## **Proposed amendments to ECE/TRANS/WP.29/2017/67 (Draft General Guidelines for regulatory procedures and transitional provisions in UN regulations)**

Modifications to ECE/TRANS/WP.29/2017/67 are shown in strikethrough and bold/underline.

Figure 1  
**Illustration of a transitional period for a vehicle, or vehicle systems, covered by a UN Regulation and its amendments**

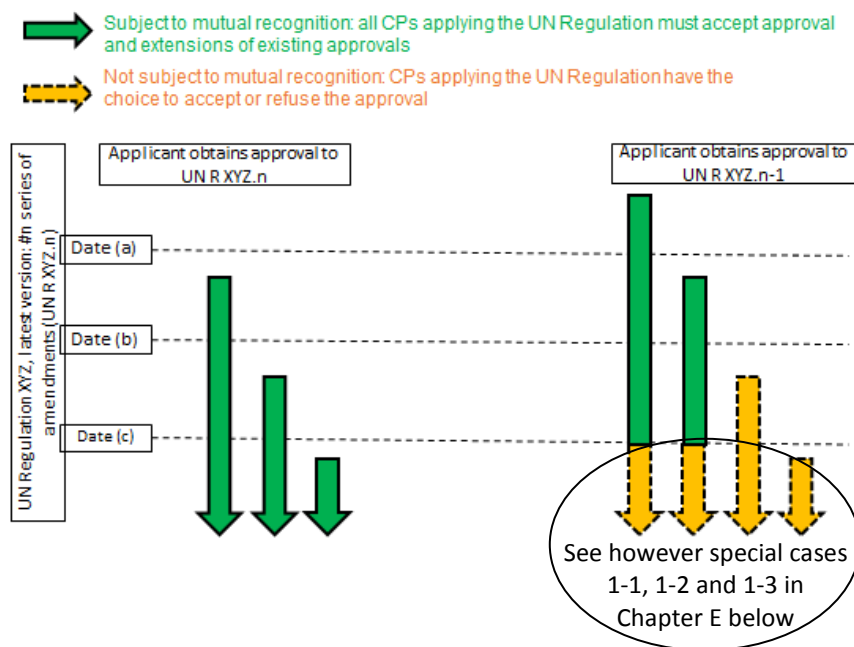
Note: Existing approvals remain valid, but Contracting Parties are not obliged to accept them as from date (c). **If (b) and (c) dates are not written in to the transitional provisions, they are regarded as identical to date (a).**

Para. 25 : It is to re-instate a guideline that already exist in the present guidelines (TRANS/WP.29/1044 ) that in the absence of transitional provisions, the new series of amendments apply from the date of entry into force.
